## Field Retrofit Kits: REX1171A REX1172A

## Corrective Action Instruction Sheet for SRN-1206

68P81086C03-A

Figure 1. Conductive Pad Placement

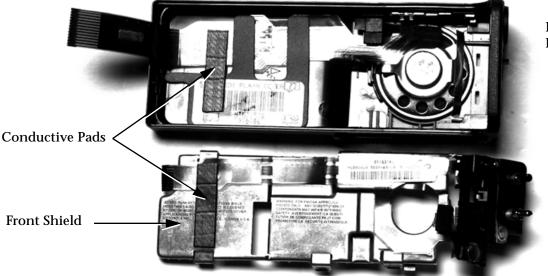
- 1. Per service manual disassembly procedure, remove the front cover, the front shield, and the controls flex. Discard those three parts.
- 2. Replace the front cover, front shield, and controls flex with the replacement items from the retrofit kit.
- 3. Refer to Figure 1 for placement of conductive pads. Remove backing from the conductive pads and stick them to the surfaces as illustrated in Figure 1.
